Re: Source Materials License SUA-1534
Docket No. 40-8943
Mine Unit 1 Restoration; Response to Request For Additional Information

**Crow Butte Resources, Inc.
Response to U.S. Nuclear Regulatory Commission
Request For Additional Information**

Mine Unit 1 Groundwater Restoration Completion

Mine Unit 1 Groundwater Restoration Response to Request For Additional Information

Figure 3
Mine Unit 1
Monitor Well Locations

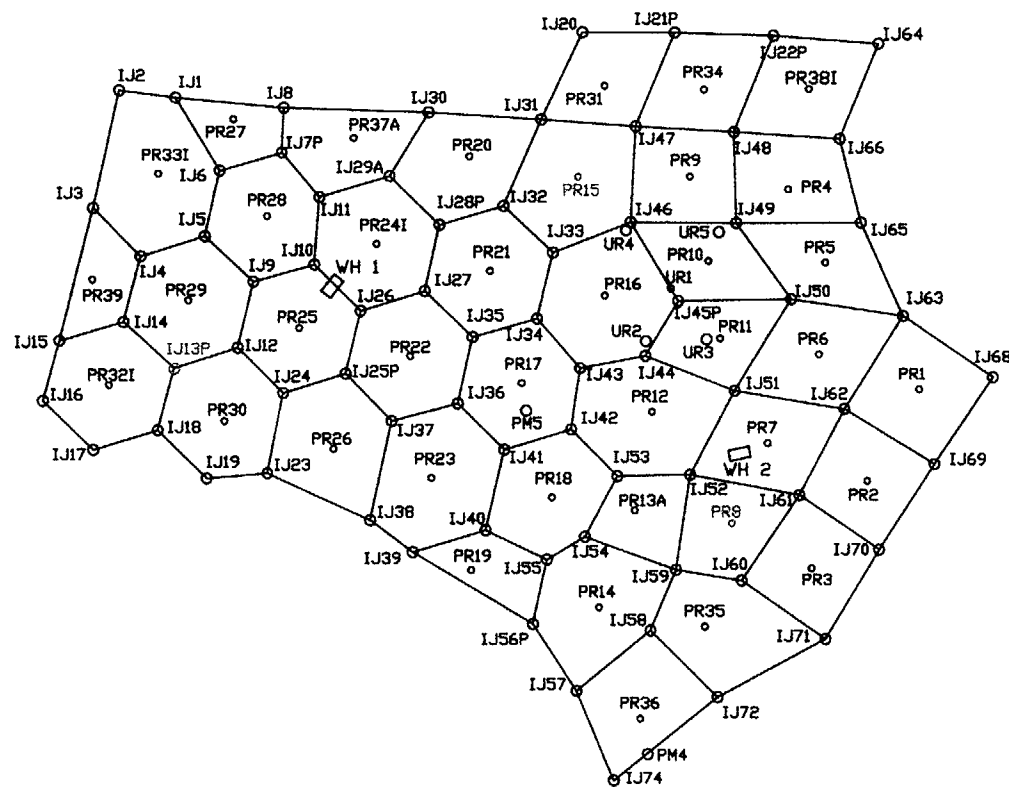
The licensee must submit additional monitoring data to show that all measured constituents have reached the restoration goals in License Condition 10.3 and that the restored concentrations are stable, as demonstrated by no strongly increasing concentration trends through time. These data should be presented in time versus concentration graphs of each constituent, with the restoration standard indicated on the graph. Tables of numerical values used to compile the graphs, and laboratory measurements should also be included. These data should include the time period just prior to and during the stabilization period, and measurements taken since the end of the 6-month stabilization period. The licensee must also submit iso-concentration maps of uranium, radium-226, total carbonate, and total dissolved solids in the Unit 1 restoration wells and perimeter monitor wells, once the restoration has stabilized, to illustrate well field water-quality conditions at the end of stabilization.

To provide additional data supporting the assertion that Mine Unit 1 is relatively stable, CBR has summarized monitoring data for three Mine Unit 1 baseline restoration wells that have been sampled routinely since the stabilization period. These wells were designated as perimeter monitor wells in December 1999 following the approval of the Mine Unit 1 restoration by the NDEQ. The three wells (PR-8, PR-15 and IJ-13) were selected to serve as perimeter monitor wells for Mine Units 2 and 3 and are evenly distributed in Mine Unit 1. Figure 3 shows the location of these three wells within Mine Unit 1.

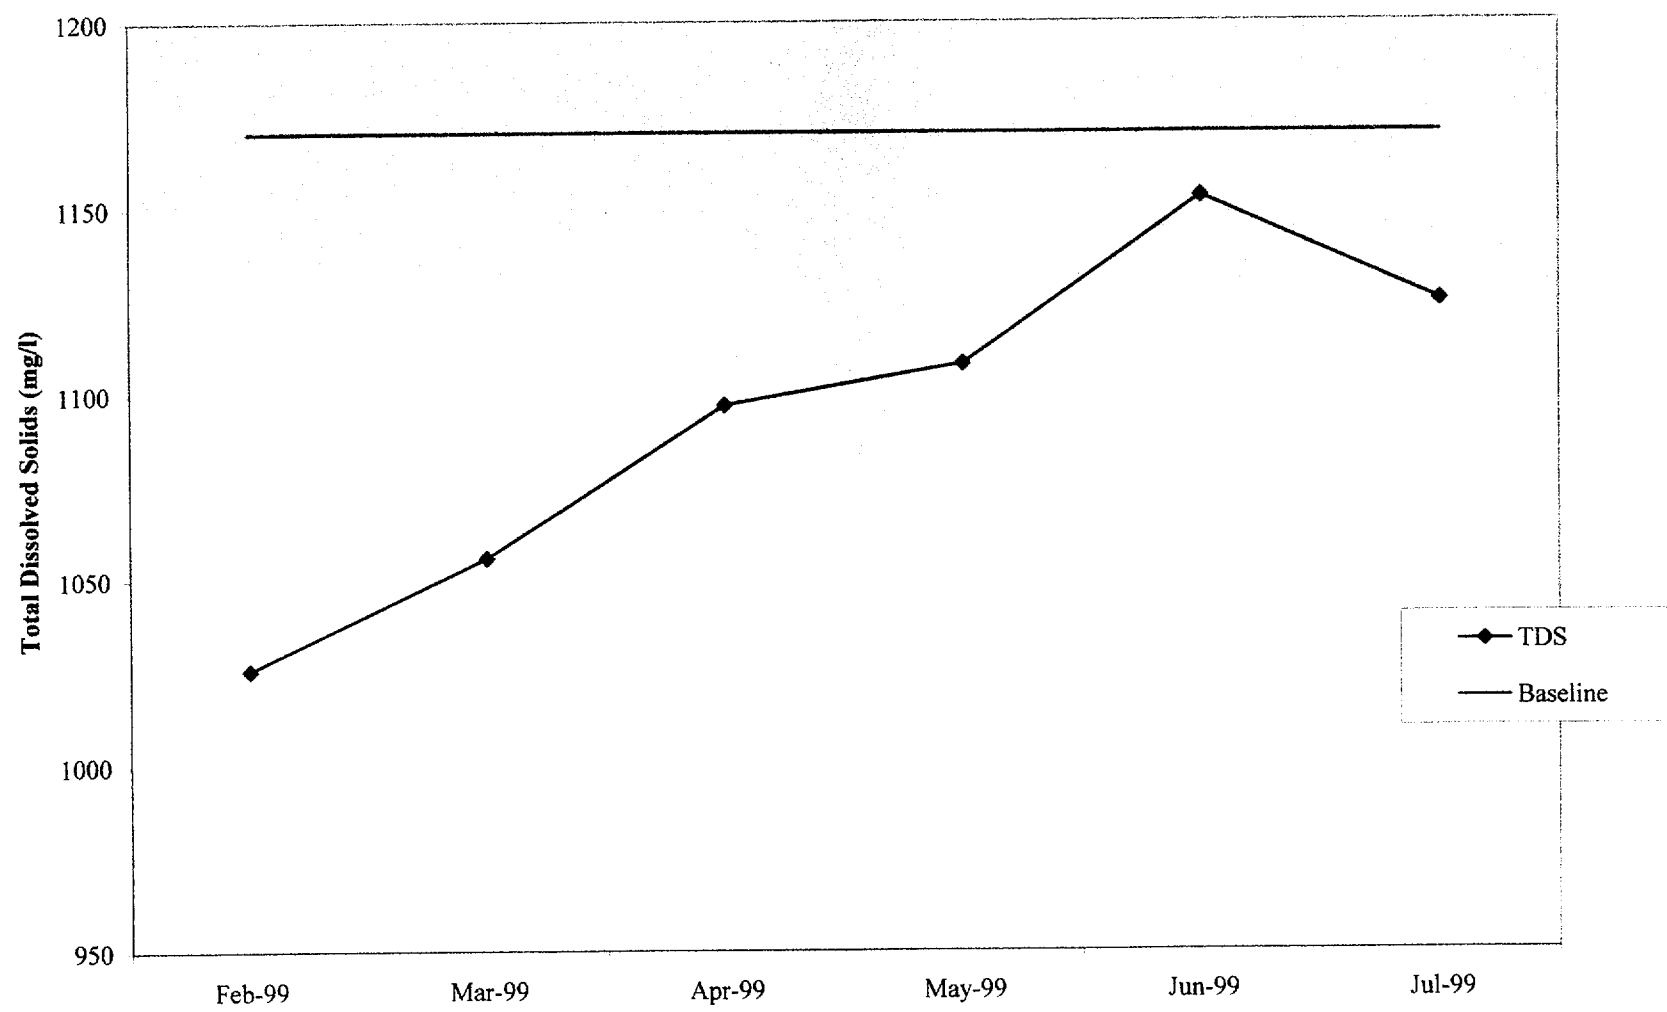
Describe how the well field contamination flares, between the wellfield and the perimeter monitoring wells on the north and south sides of Unit 1, have been restored. Provide any monitoring data, analyses, or calculations that show restoration has occurred in these areas.

In Section 3.2 of the Mine Unit 1 Restoration Report, CBR describes the limited use of groundwater sweep during restoration due to the configuration of the surrounding mine units. In place of ground water sweep, CBR used a series of ground water transfers to replace high TDS mining solutions with baseline TDS groundwater within Mine Unit 1. The transfers produced similar results, as would an extended groundwater sweep program, with the exception of recovering mining solutions that had flared beyond the mine unit boundaries. Although some mining solution was recovered during the groundwater sweep phase of restoration, the solution was primarily recovered during reverse osmosis treatment of the edge patterns adjacent to these areas. This fact is demonstrated when comparing the number of pore volumes of reverse osmosis treatment needed to return the edge patterns to baseline conductivity, as compared to the interior patterns. An average of 8.4 pore volumes of reverse osmosis treatment was required to return the groundwater in the north and south edge patterns of Mine Unit 1 to baseline conductivity, versus 6.0 pore volumes for the rest of the Mine Unit 1 patterns. This would indicate that flared mining solutions were drawn into these edge patterns during reverse osmosis treatment. Since baseline groundwater conductivity was achieved in these edge patterns during reverse osmosis treatment, it would mean that the groundwater outside of these patterns was also returned to baseline conductivity, indicating that the flared mining solution was recovered from the areas north and south of Mine Unit 1 during restoration.

Appendix C. Iso-Concentration Maps for Selected Parameters

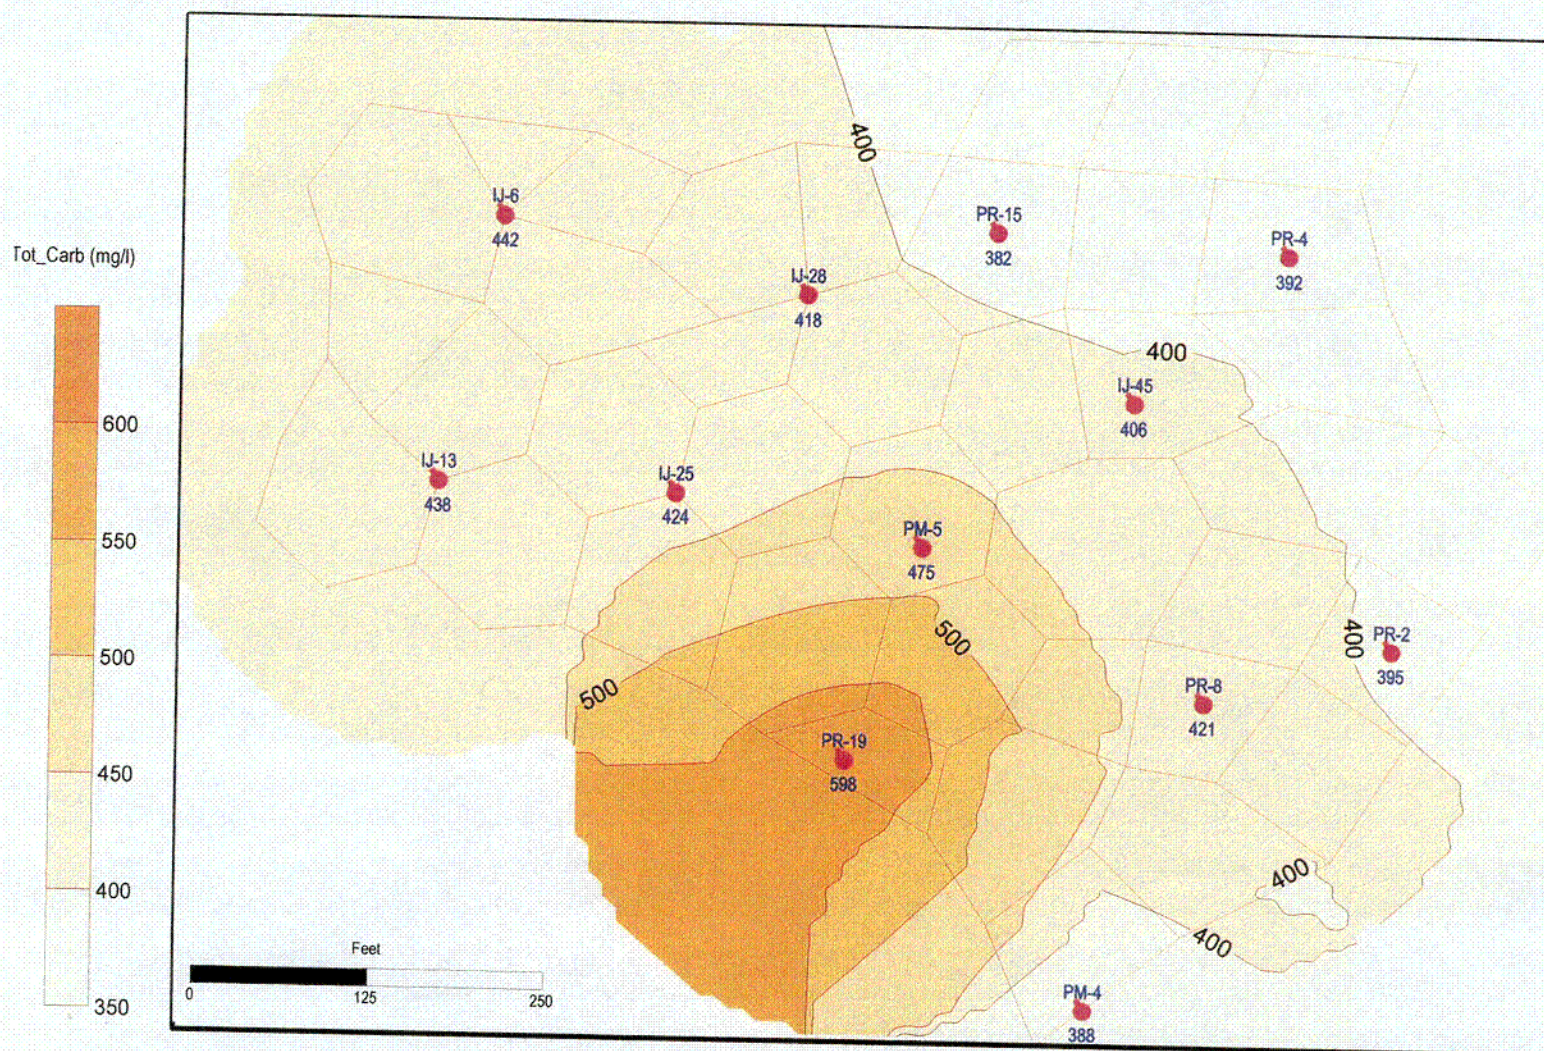
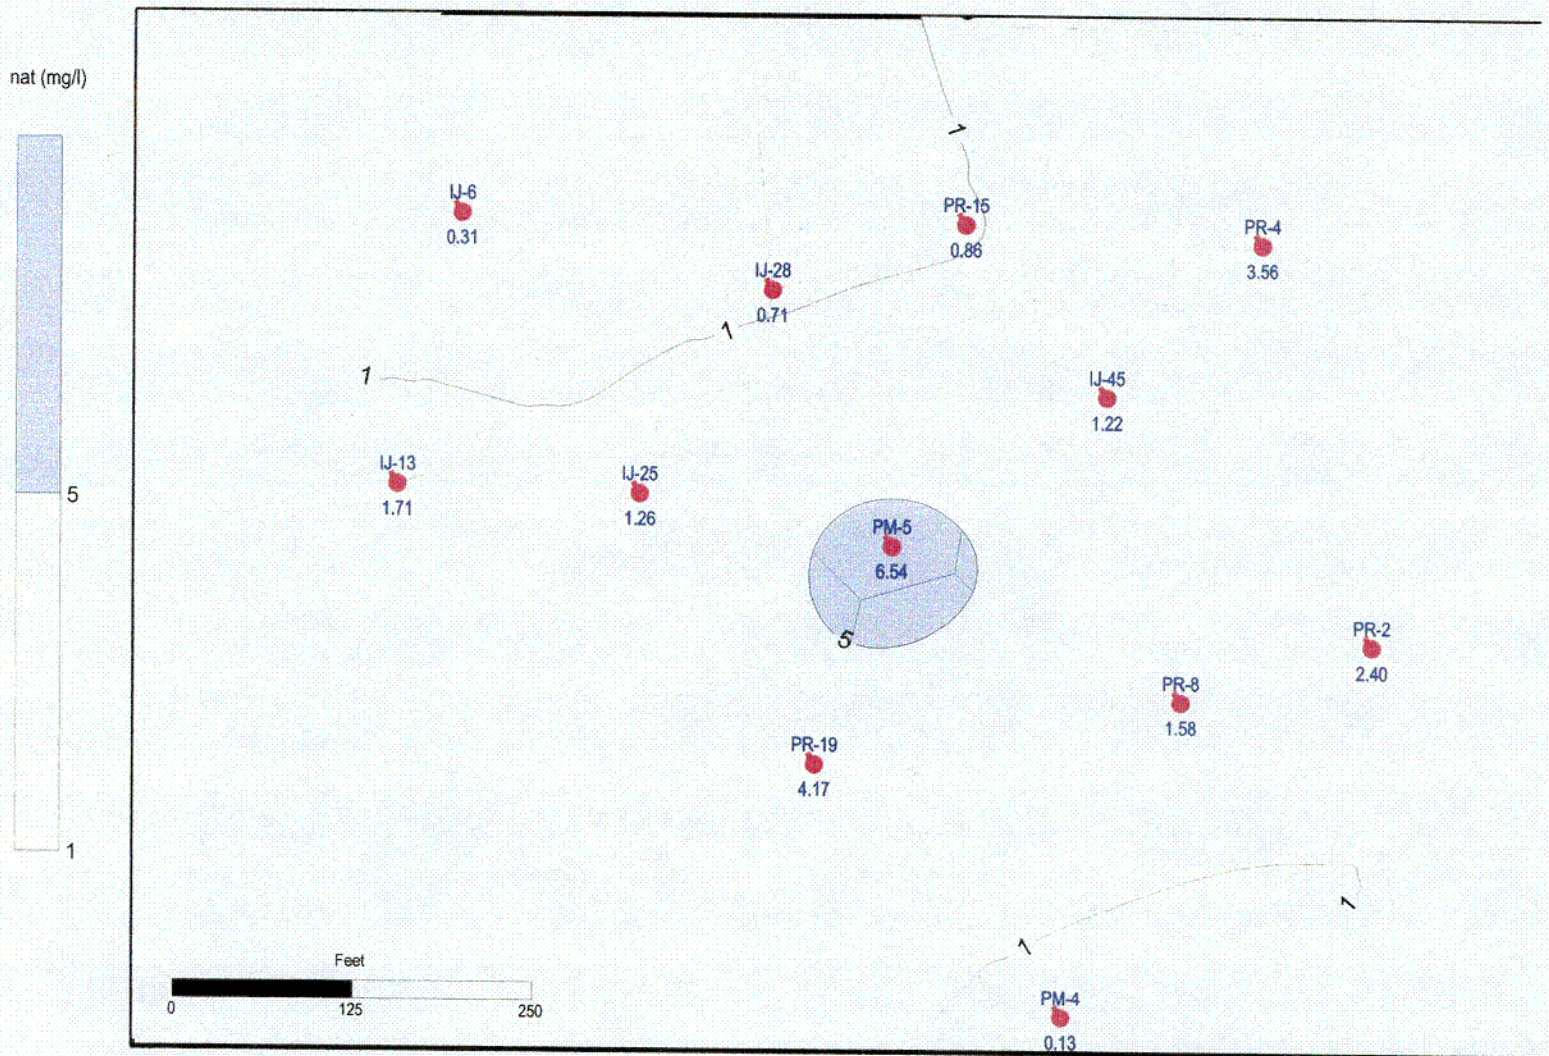
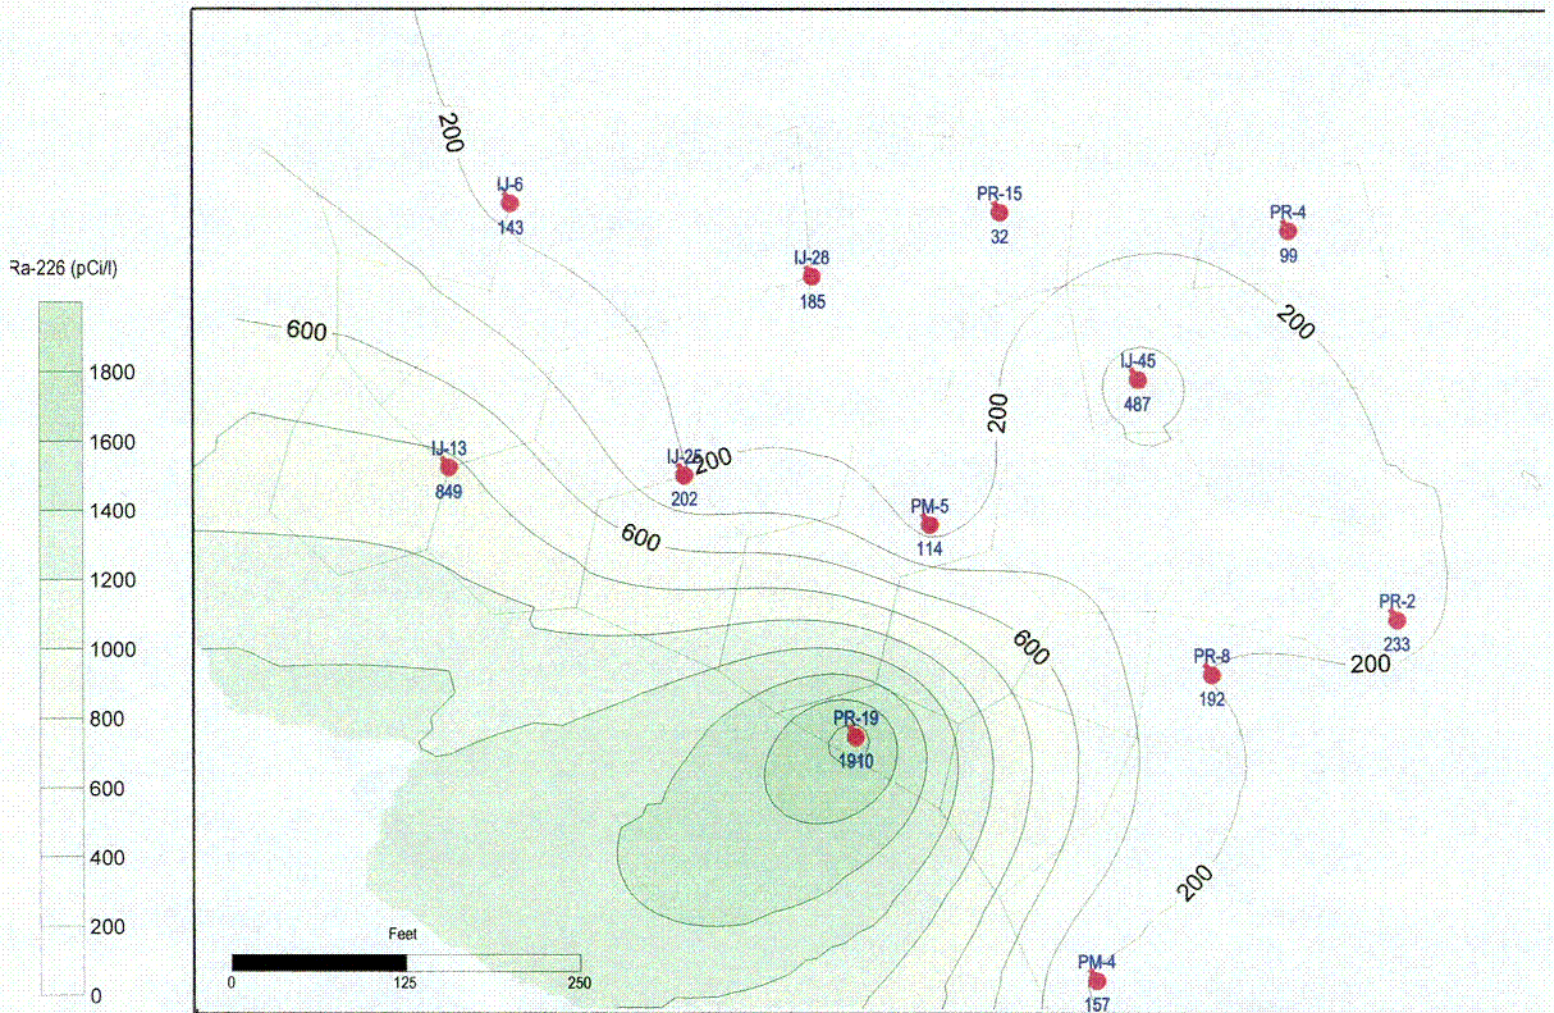
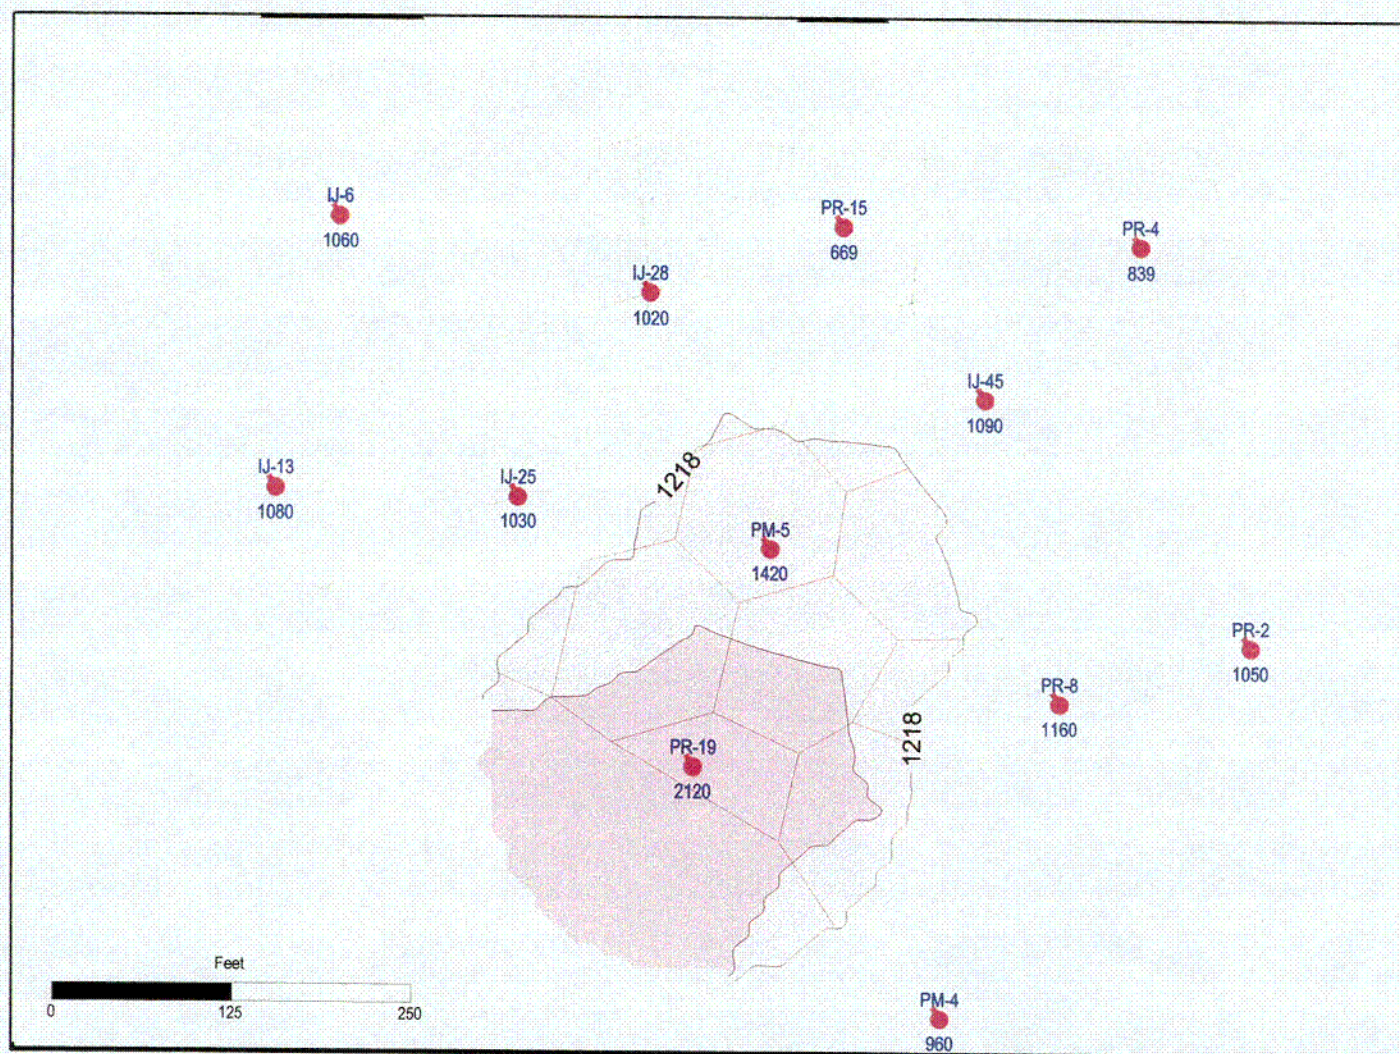
NRC requested that CBR submit iso-concentration maps for radium-226, natural uranium, total dissolved solids, and total carbonate in the Mine Unit 1 restoration and perimeter monitor wells, once the restoration is stable. As discussed in Section 3.2.2, CBR believes that the data indicates that the restoration was stable during the stabilization phase. Therefore, iso-concentration maps have been prepared from the stabilization period monitoring data.

Appendix C contains the iso-concentration maps for the parameters requested. The maps were developed from the final data set collected on July 15, 1999 from the Mine Unit 1 Baseline Restoration Wells. Data from the Mine Unit 1 perimeter monitor wells (CM1-Wells) was not used to prepare these maps as requested in the Request for Additional Information. As explained in Section 3.2 of the restoration report, these wells were no longer in service as monitor wells on that date. During the expansion of mining operations, the CM1-Wells were incorporated into neighboring mine units. Therefore, data collected from these wells would not be relative to the groundwater quality in Mine Unit 1 following restoration. The successive removal of these wells as active perimeter monitor wells was approved by NRC in the Notices of Intent to Operate for Mine Units 2, 3 and 4.

When reviewing these maps, it is important to keep in mind the limitations of the gridding programs, and the nature of the parameters being modeled. These iso-concentration maps were generated using a linear Kriging gridding method within the contouring program, Surfer (published by Golden Software, Golden, Colorado). This method produces a regularly spaced, rectangular array of concentration values collected from the Baseline Restoration Wells. These wells are not evenly spaced over the wellfield area, which leads to missing data in the grid pattern. The gridding method interpolates concentration values where no data exists. Therefore, the contours extending beyond the boundaries of the wellfield represent an interpretation by the gridding program where there is no data.

As mentioned above, the gridding program can only produce a grid map from the data provided. The gridding program does not recognize the geochemical reactions that take place between the groundwater and the host formation. This is another limitation associated with the gridding program. As an example, the iso-concentration map produced for radium-226 generates high concentration contours some distance beyond the southwest boundary of Mine Unit 1. However, due to the strong sorption affinity of radium-226, it is unlikely that these extrapolated concentration levels present an accurate representation of the radium-226 concentrations in that area. It has been documented at numerous uranium mine and tailings disposal sites that radium-226 does not migrate a significant distance from its source.
